Walter Williams - Fwd: FW: FW: FW: Petition #1768 - Drawing Review (2nd Request)

provide this information with 1768

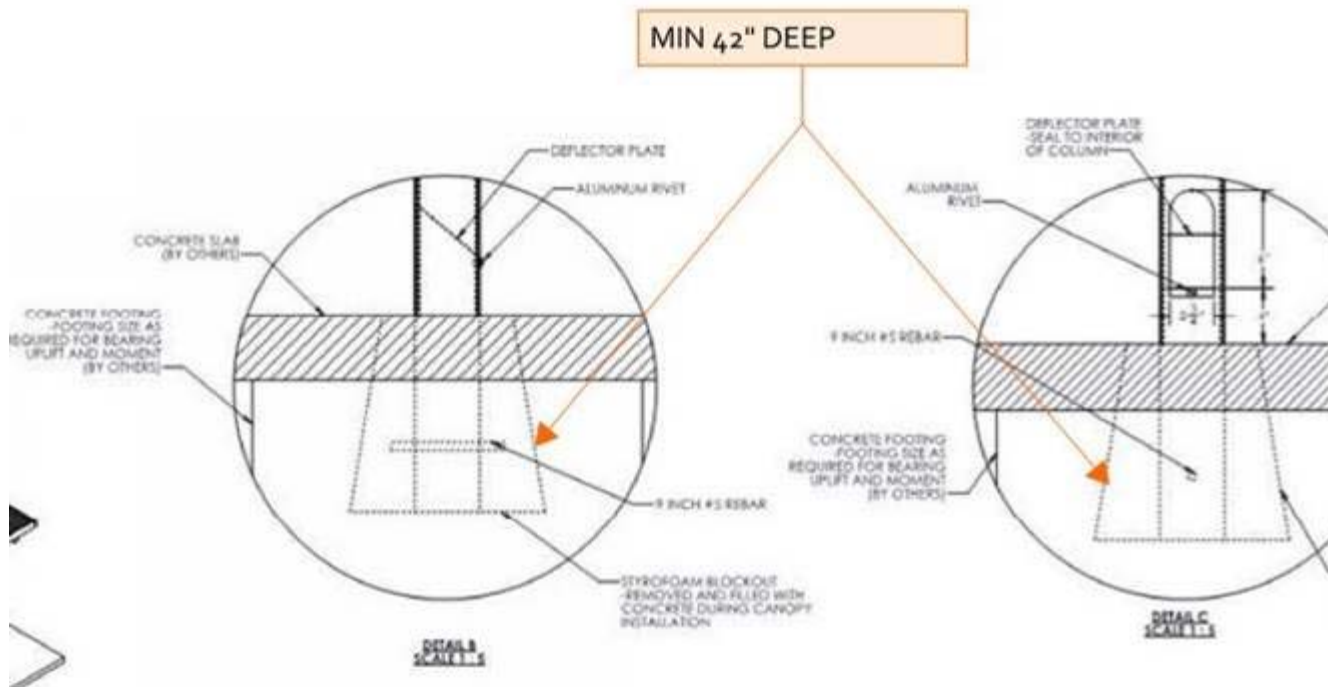
Per request from DWSD we need the mounting depth.

For encroachments such as the Petition 1819 where items are mounted into the ground, can the petitioners please be asked to provide the depth below ground of the mounted items not just the width/length/height?
Thanks

Attached is the revised Petition drawing for your review and approval. Look at the northeast corner where the measurement from the property line to the beginning of the encroachment on Farmer St. is 6 ft.

Per the DWSD request below, I have provided the detail below which we received from the Architect for the canopy support fasteners. The depth would be 42" for frost. Please let me know if there are any concerns with this fastener type/plan.

Attached is an exhibit showing the awning. The location of the poles is not exact, I am sure they will be away from the curb and attached to the walk from the surface. The fasteners will not extend deeper than the sidewalk section.

The dimension he is asking about should actually be **5.3 ft** from the property line to the beginning of the encroachment. It is the angled dimension to the ramp that is 6 feet (for walking space). Please let him know, and if I need to add that dimension to show it, I can do that too.
